WCT PARKING FACILITY
COMPUTER-PROJECTED RENDERING of ILLUMINATION
provided by
PROPOSED COMPROMISE LIGHTING SCHEME

PROPOSED COMPROMISE LIGHTING SCHEME MODEL:

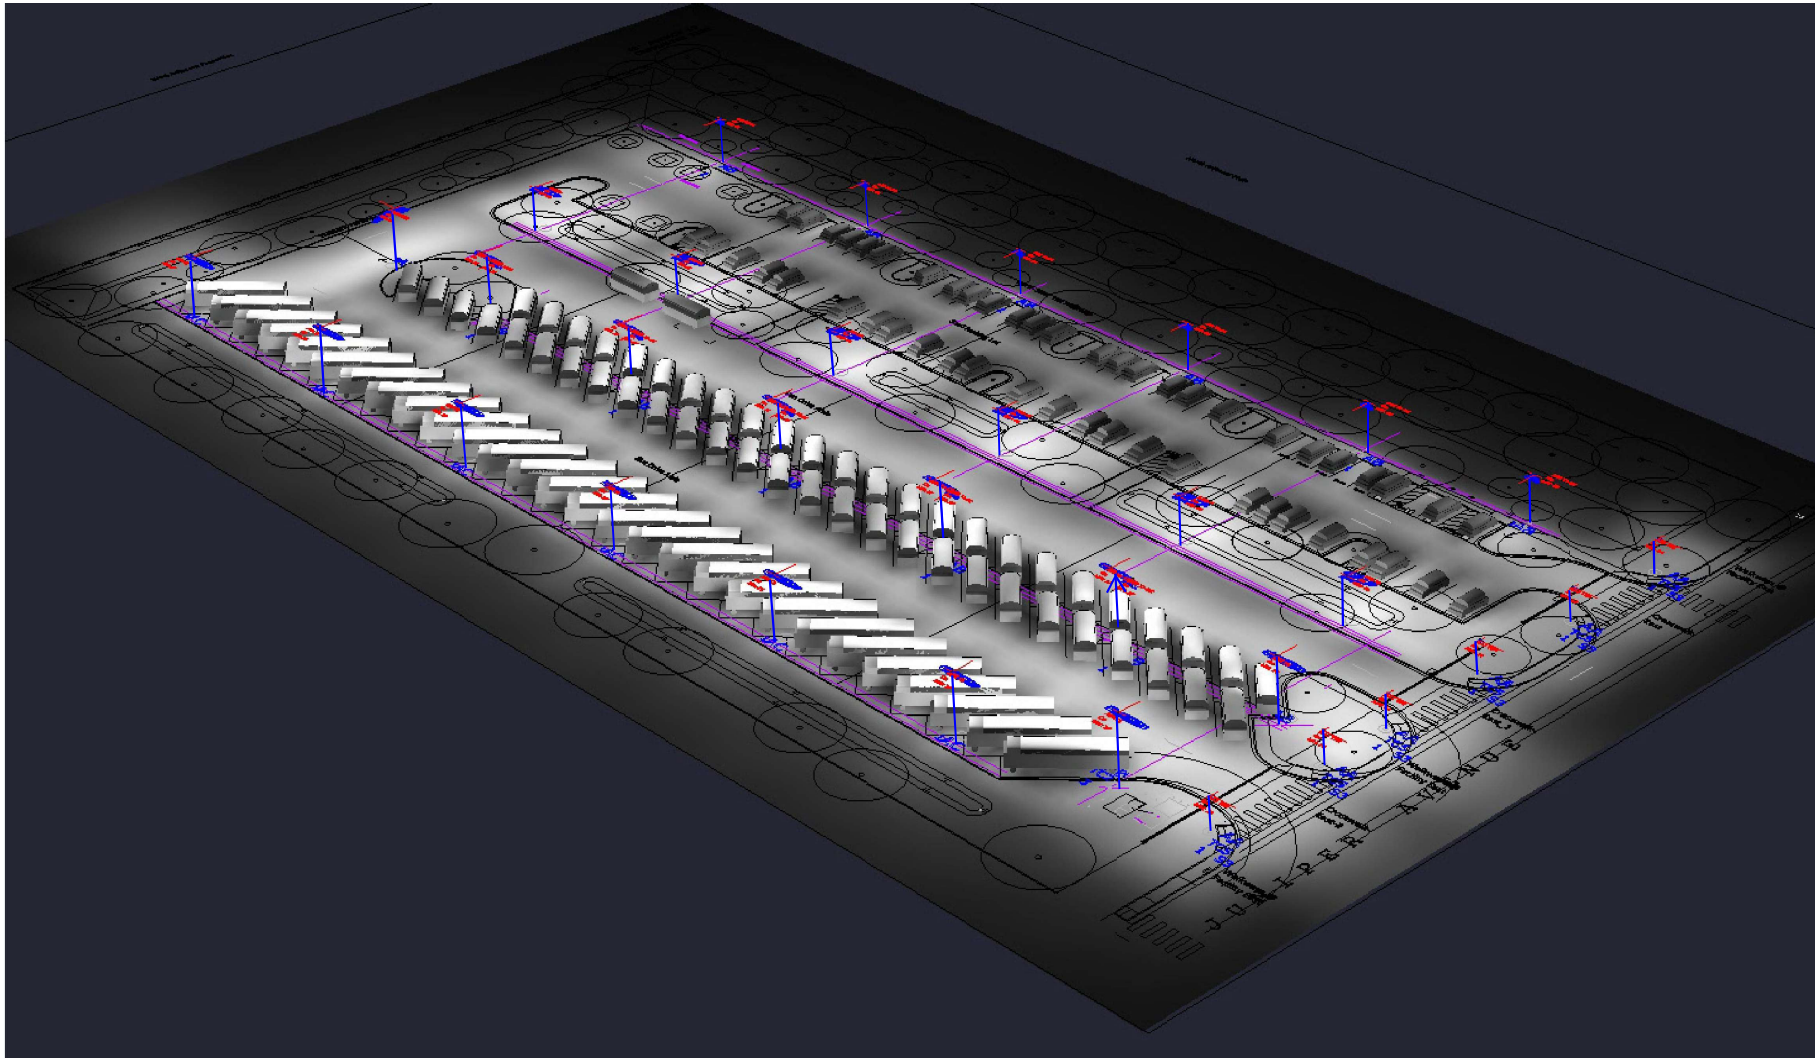
- 1) Light Pole *locations* for this Design & Computer Model are identical to those included in the ORIGINAL PERMITTED SCHEME; the number of heads are revised and outputs reduced for some poles.
- 2) Poles for Luminaires illuminating the Bus/Van Lot are set at 27ft above finished grade (lowered from 30ft & 35ft in the Permit Set).
- 3) Poles for Luminaires illuminating the Staff Auto Parking Lot are set at 20ft above finished grade (lowered from 27.5ft & 25ft).
- 4) Although 2700 deg. K LED's are available now as an added cost Option, this Option *reduces luminaire efficiency* by 14%, as compared with the standard 3000 deg. CCT LED'S specified. Projected illuminance levels for these computer Models are based on the specified 3000K LED's. To determine light levels for this Scheme using the Optional 2700K LEDs: *take 86% of levels shown on ISOFOOTCANDLE PLOT, Sheet C-2.*
